APPLICANT: Texas Utilities Electric Company (TUEC)
 FACILITY: Comanche Peak Steam Electric Station, Units 1 and 2
 SUBJECT: SUMMARY OF MEETING TO DISCUSS THE COMANCHE PEAK TECHNICAL REVIEW TEAM (TRT) FINDINGS RESULTING FROM QUALITY ASSURANCE/QUALITY CONTROL (QA/QC) ALLEGATIONS

APPLICANT: Texas Utilities Electric Company (TUEC)
FACILITY: Comanche Peak Steam Electric Station, Units 1 and 2
SUBJECT: SUMMARY OF MEETING TO DISCUSS THE COMANCHE PEAK TECHNICAL
REVIEW TEAM (TRT) FINDINGS RESULTING FROM QUALITY ASSURANCE/
QUALITY CONTROL (QA/QC) ALLEGATIONS

Figure 1. Hardware Examples

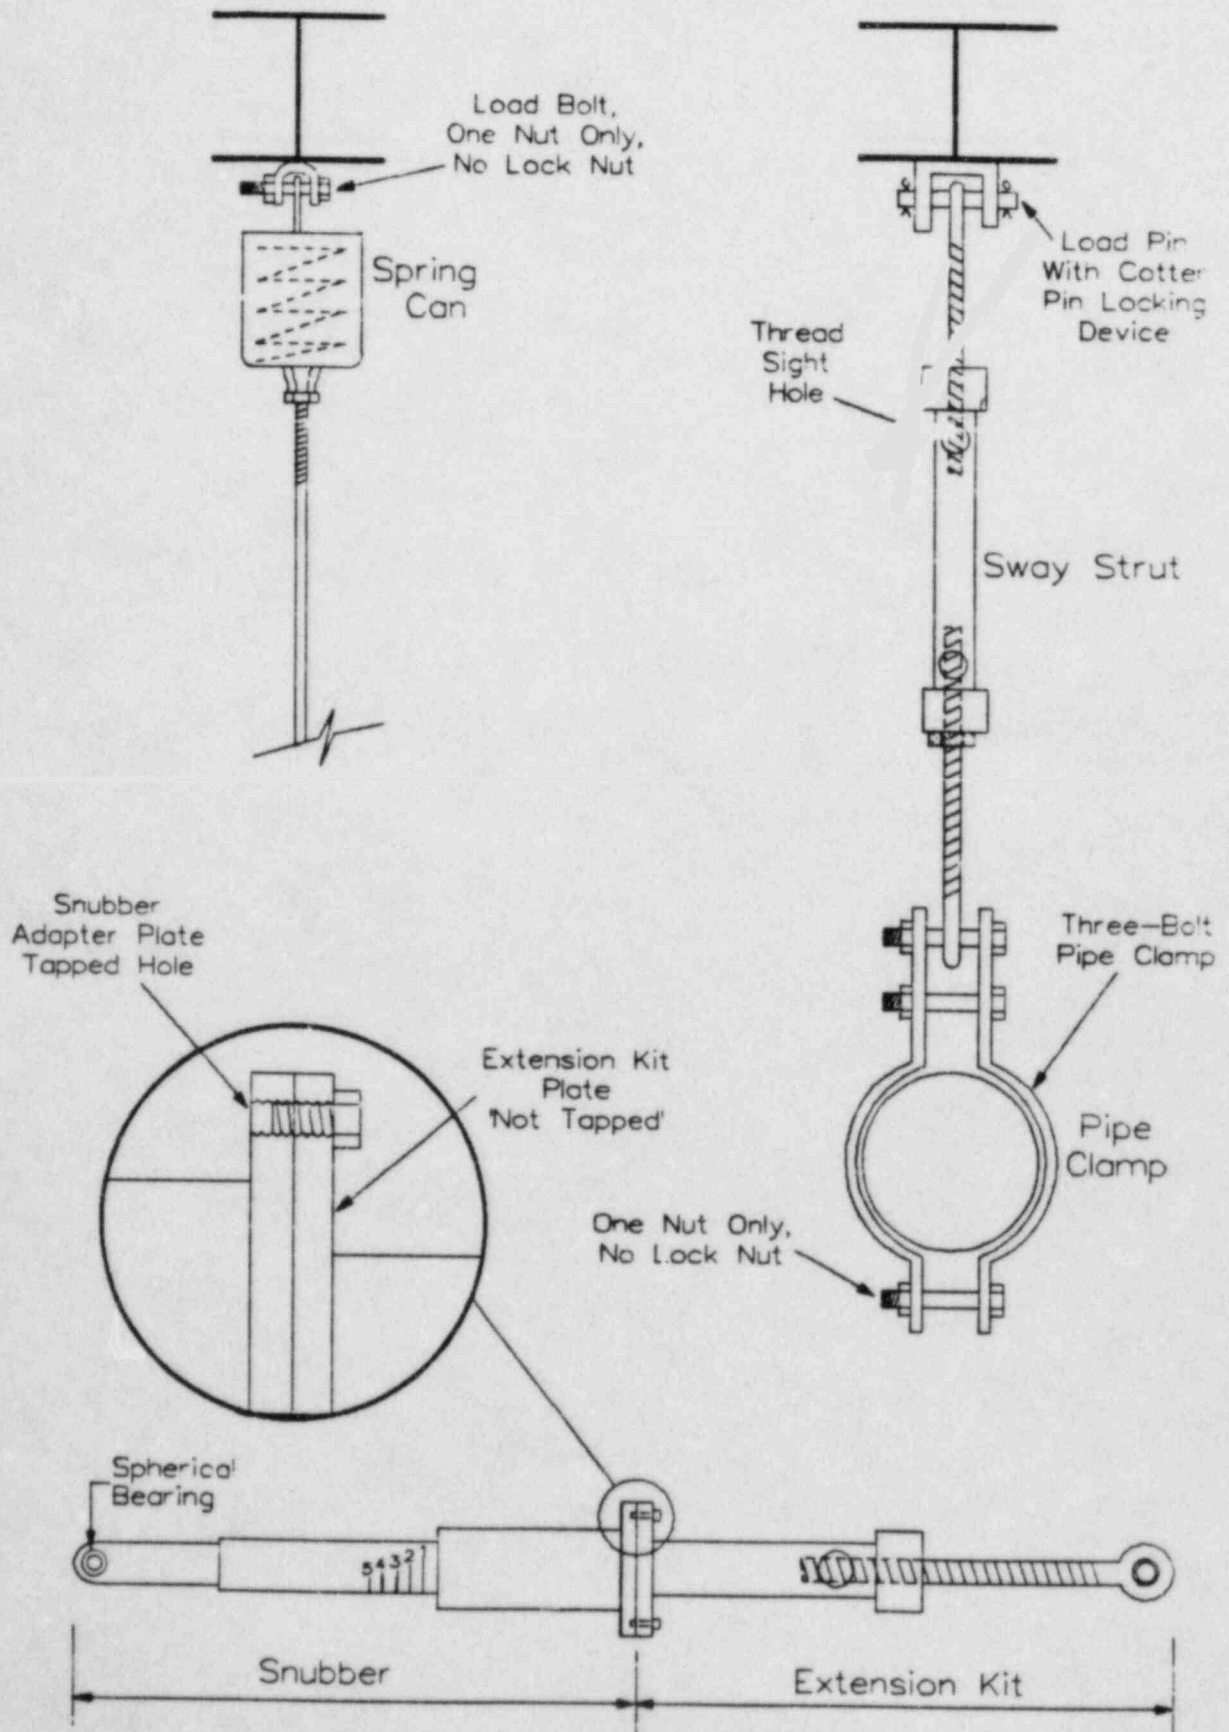
- 1) QC INSPECTIONS ARE INEFFECTIVE
- 2) CRAFT CONSTRUCTION IS FAULTY
- 3) HARDWARE IS NOT PER AS-BUILT DRAWINGS
- 4) HARDWARE POTENTIALLY NOT REPRESENTED CORRECTLY
IN THE FINAL STRESS ANALYSIS
